SUBARU.

REPAIR PROCEDURE

APPLICABILITY: 2009-2012MY Forester
 2010-2011MY Legacy and Outback
 2006-2012MY Tribeca

SUBJECT: Preliminary Inspection and Repair Procedure
 for Puddle Light Campaign WQE-41

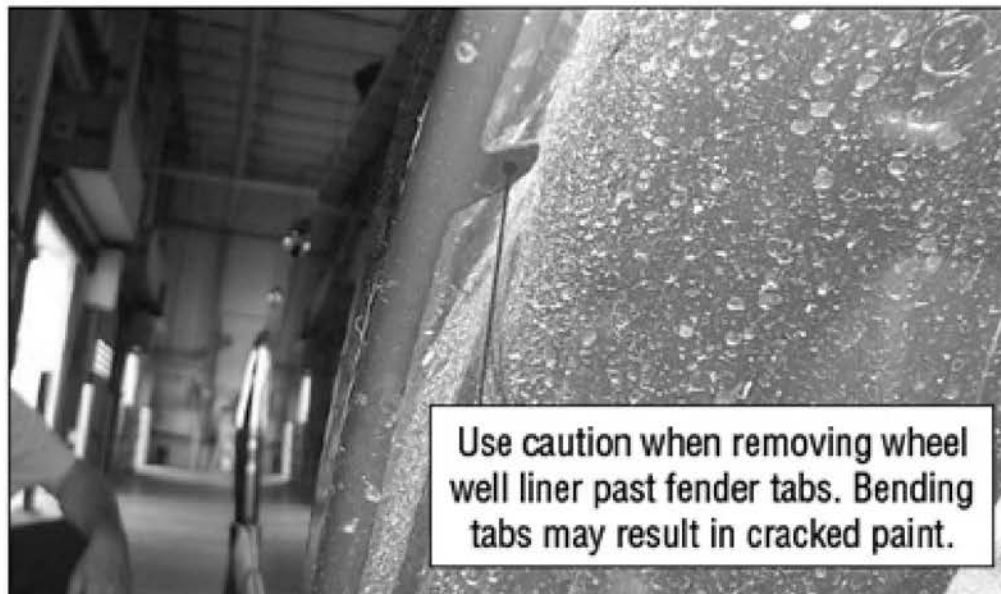
- A Forester is shown in the photo on pg. 4 for illustration only.
- Splash guard removal may also be required for access to the splash shield retaining clips.
- Retaining clip locations will vary by model.
- See **Appendix B** for samples of retaining clip locations by model.
- The photos below show a puddle light harness without the in-line mini-fuse on the left and the current replacement harness with the in-line mini-fuse on the right.

No mini-fuse installed

With mini-fuse installed

Fused Mini-Harness

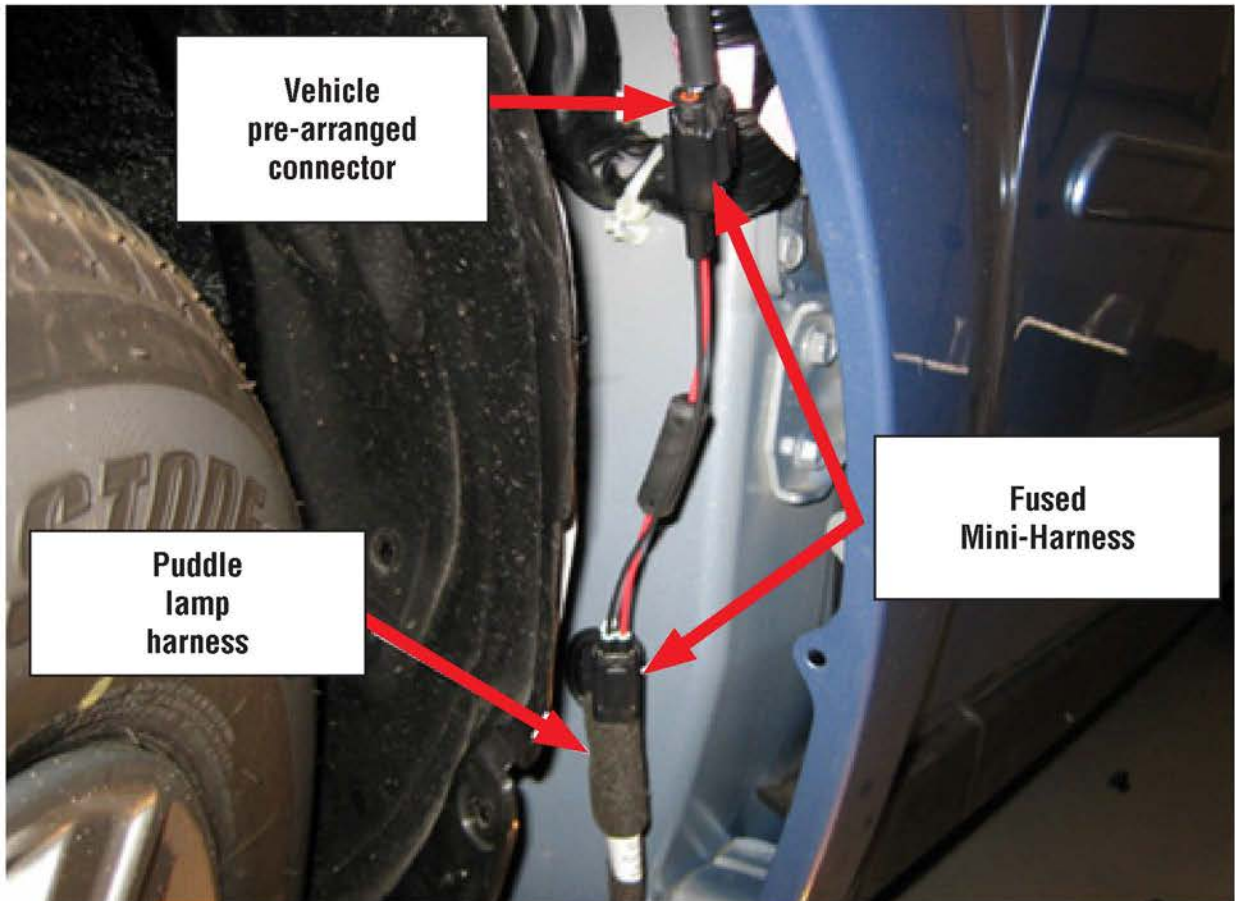
- b. Proceed to check the other side of the vehicle starting again at Step 2. Once inspection of both sides of the vehicle is complete, proceed to Step 5.
- c. If no in-line fuse or Fused Mini-Harness is present, unplug the puddle light harness connector from the vehicle body harness connector and install the Fused Mini-Harness as shown in the reference photos below.

Route the completed harness behind the splash shield. Use electrical tape to secure any excess harness out of the way avoiding any areas where it may be exposed to sharp edges or become pinched. **Do not reassemble yet.** Once both sides of the vehicle have been completed, proceed to the next step.
